STAFF'S
REQUEST ANALYSIS
AND
RECOMMENDATION

07TS0163

Andrew Gibb
(Queensgate)

REQUEST: Tentative Subdivision plat approval.

Queensgate Subdivision Regional Traffic Distribution on Area Roads

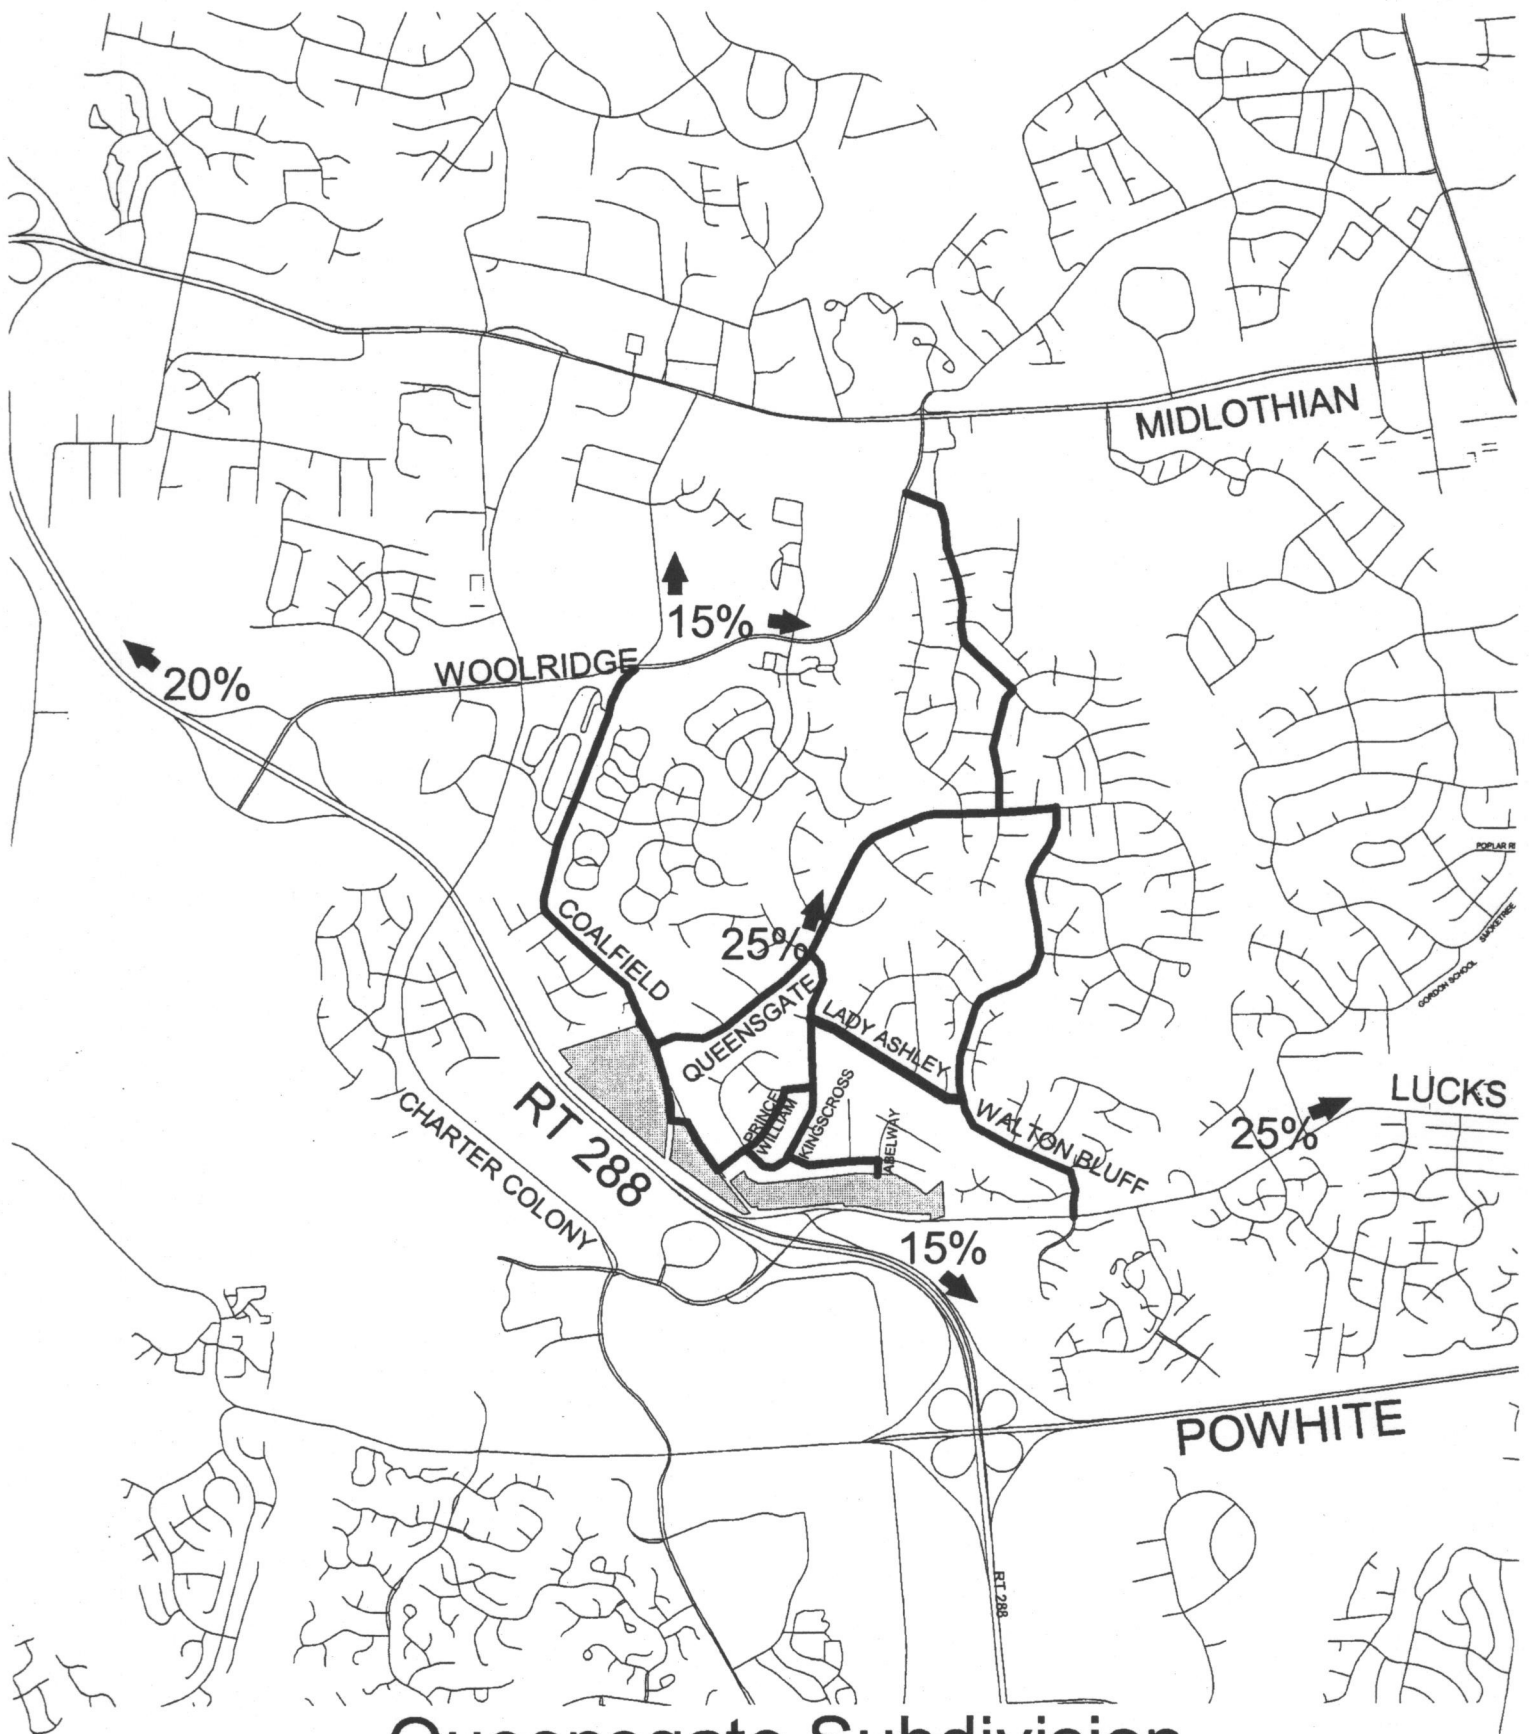
Based on the Queensgate Tentative Subdivision Plat, staff assumed a regional distribution of the traffic that is anticipated to be generated by this development onto the streets in Queensmill Subdivision (Attachments 3 and 4). Based on staff’s analysis, below is the anticipated traffic volumes projected for various streets.

Queensgate Subdivision Projected Traffic Volumes on Area Roads

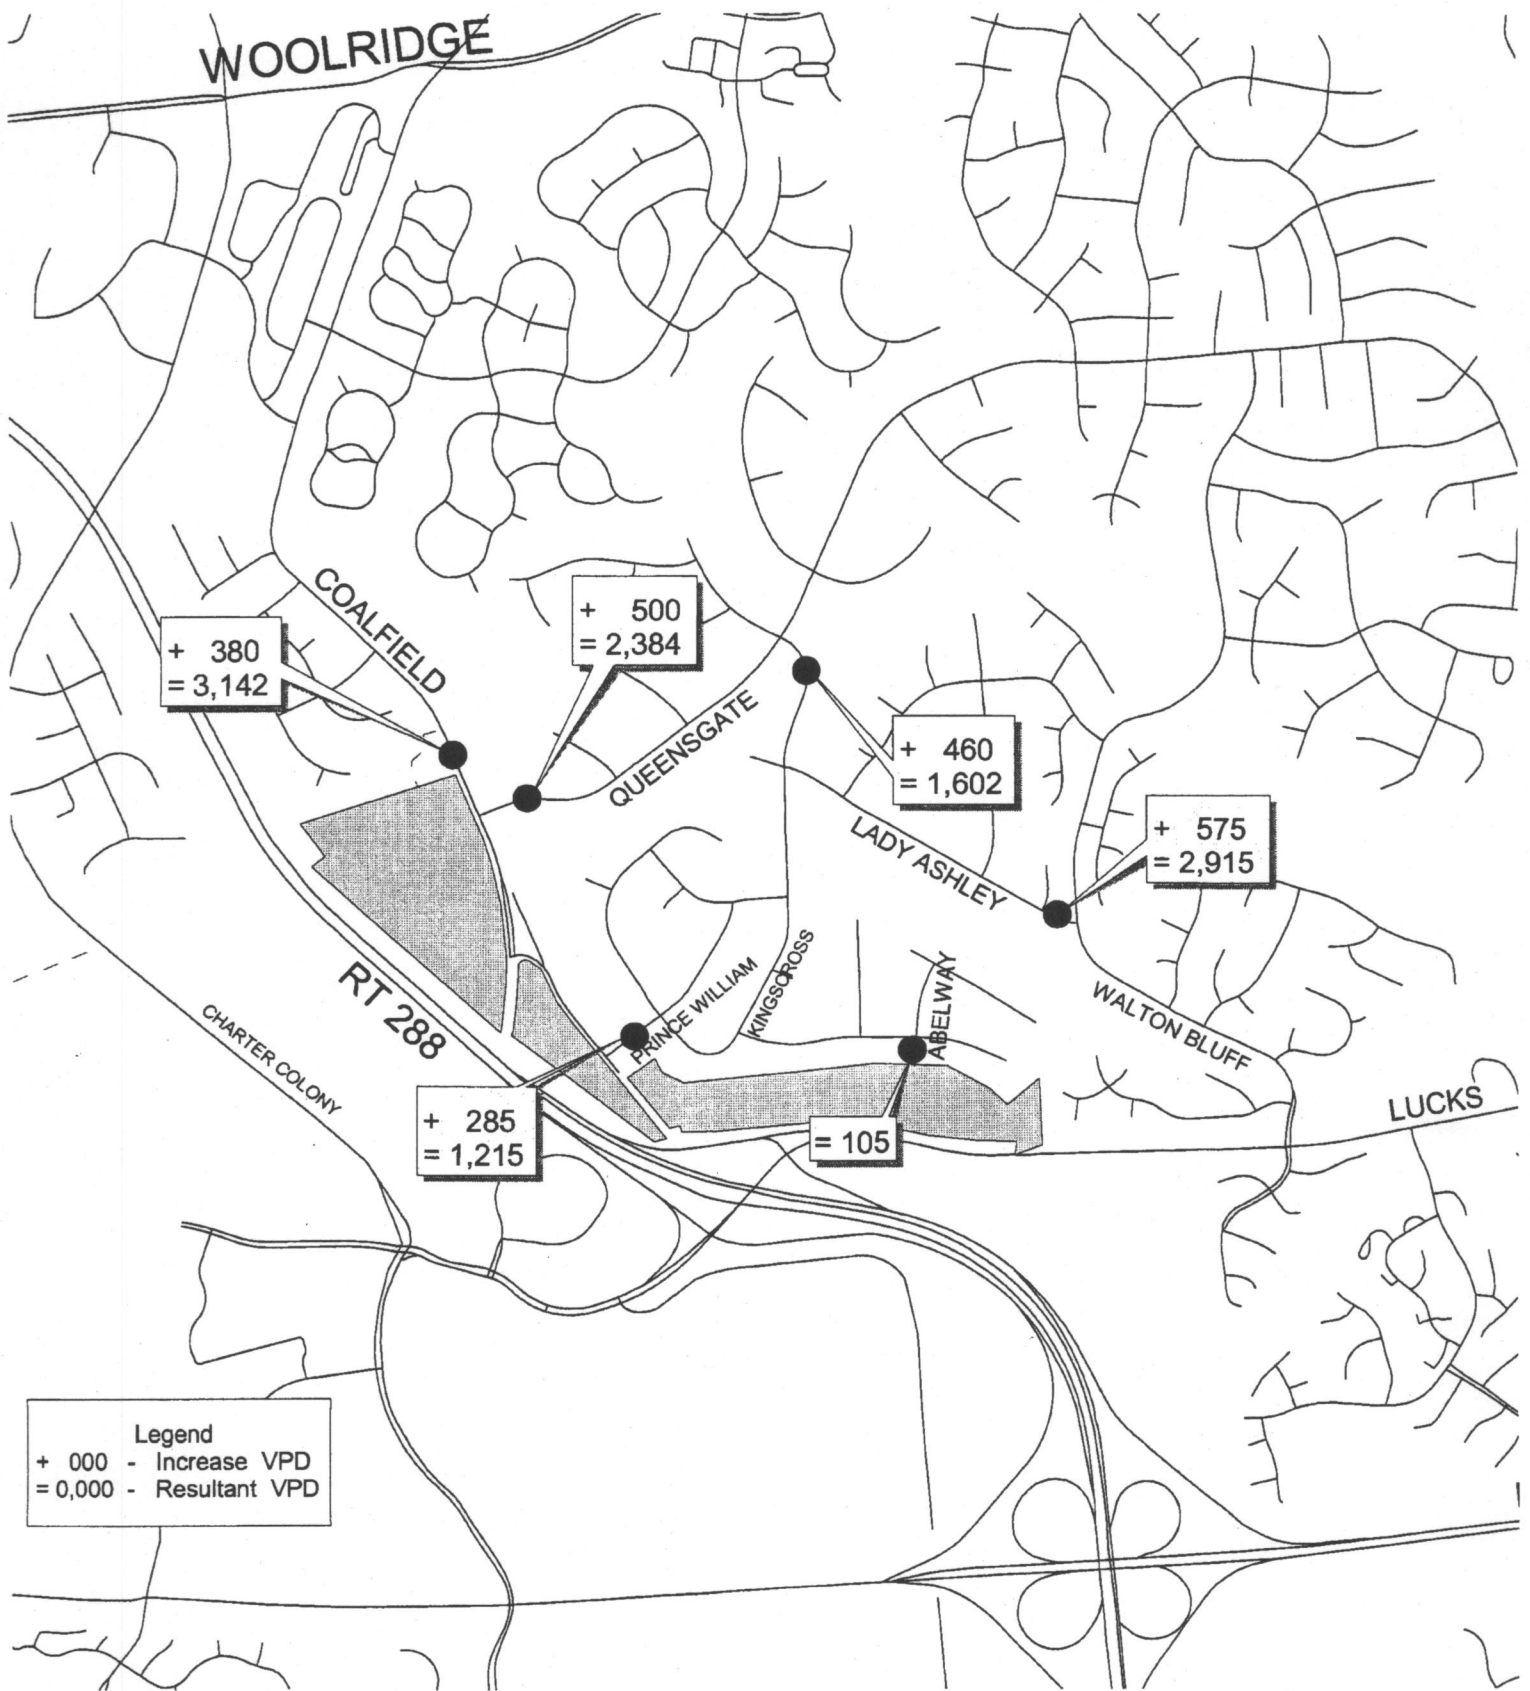
<u>Road Segment</u>	<u>Increase VPD</u>	<u>Resultant VPD</u>
Coalfield Rd just north of the proposed Queensgate Subdivision	380	3,142
Prince William Dr at Coalfield Rd	285	1,215
Queensgate Rd between Coalfield & Kingscross	500	2,384
Kingscross Rd between Queensgate & Lady Ashley	460	1,602
Lady Ashley Rd between Queensgate & Walton Bluff	575	2,915
Abelway (stub road right-of-way)	105	105
